LIC-16-0011
April 4, 2016

Fort Calhoun Station (FCS), Unit 1
Renewed Facility Operating License No. DPR-40
NRC Docket No. 50-285

Subject: Notification of Alternative Implementation of REC-111 and REC-137 from the Original License Condition

OPPD's Evaluation of Alternative Implementation of NFPA 805 Proposed Modifications

Figure 1

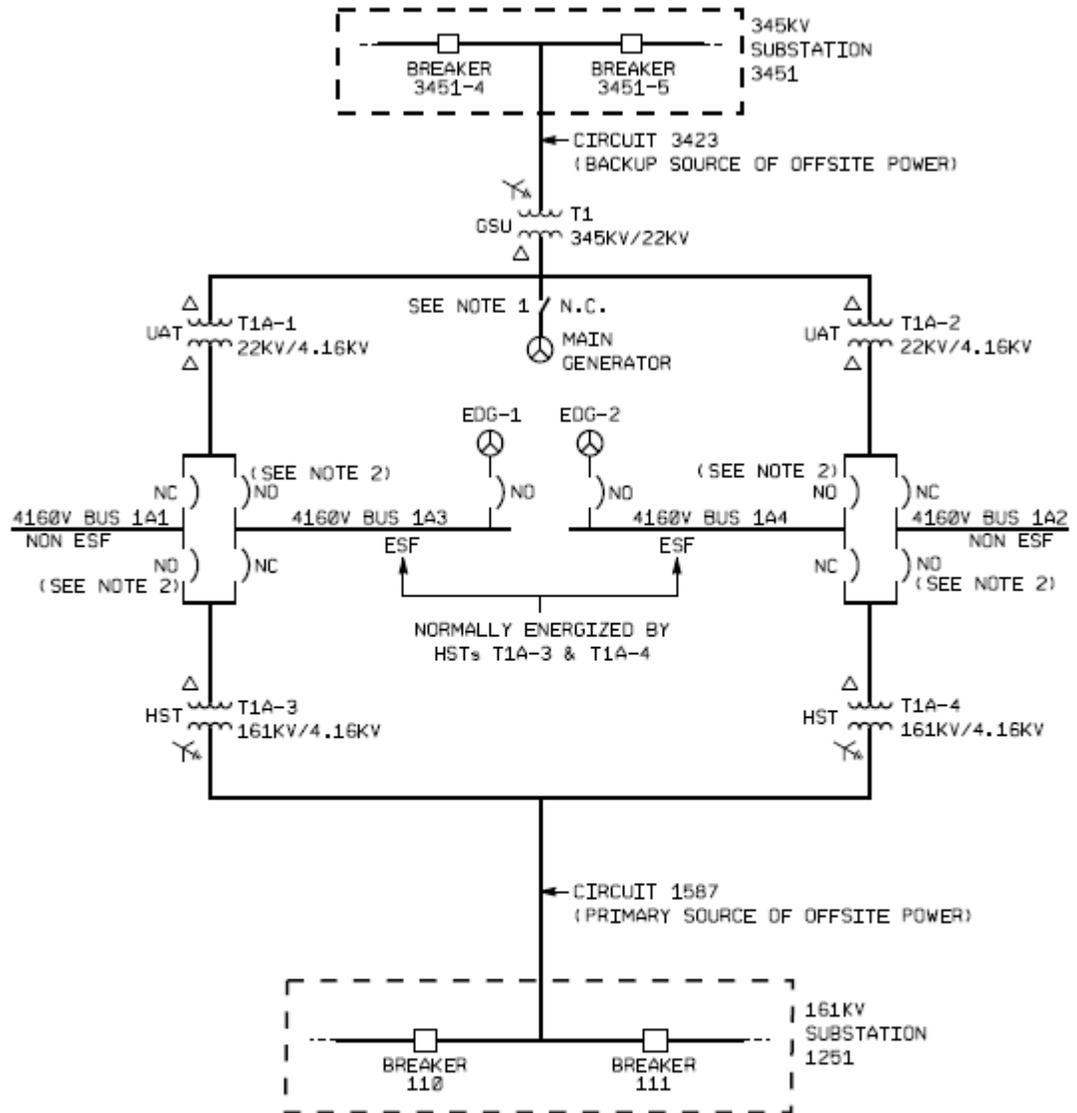
The 4160 VAC circuit breakers and associated cables that control the alignment of offsite power to buses 1A3 and 1A4 are located in the switchgear rooms and are separated by train. High voltage circuit breakers located in the switchyard can be controlled from the main control room via cables that are currently routed through both switchgear rooms, i.e. through both fire areas 36A and 36B. Refer to the attached one-line diagram, Figure 1, for additional details regarding the layout of the FCS electrical distribution system.

The alternative modification, EC 58160 (Reference 3.15), will re-route selected cables so that a HEAF and subsequent fire occurring in either switchgear room would not impair the capability of operators to restore offsite power. The modification would re-route cables associated with the control of switchyard breakers so that they would not be impacted by the postulated HEAF. In a worst case HEAF scenario, it would be possible for offsite power to be lost due to actuation of protective relays. However, with the offsite power control cables re-routed, offsite power restoration to the unaffected train would be possible during an event occurring in either switchgear room. This alternative modification would also revise plant fire procedures to provide guidance to operators for isolating the fault and restoring offsite power to unaffected buses.

The alternative modification to the installation of HEAF shields will re-route switchgear room cables associated with the control of switchyard breakers that may require operation from the control room to restore offsite power after a HEAF or switchgear room fire. The change will also add isolation fuses to ensure that the fire does not cause switchyard breakers to lose credited control power due to damage to components located in the switchgear rooms. These changes will ensure that, for certain damage scenarios in fire areas 36A or 36B resulting from HEAF or fire, offsite power can be restored.

In some HEAF damage scenarios, it may be necessary to isolate a fire-induced fault from the unaffected power train by opening a high voltage disconnect switch located outside the control room but within the FCS protected area. This operator action will be specified in FCS Abnormal Operating Procedure AOP-06-02, Fire Emergency – Uncontrolled Areas of Auxiliary Building, Sections V and VI (Reference 3.18) and is addressed in the updated fire PRA.
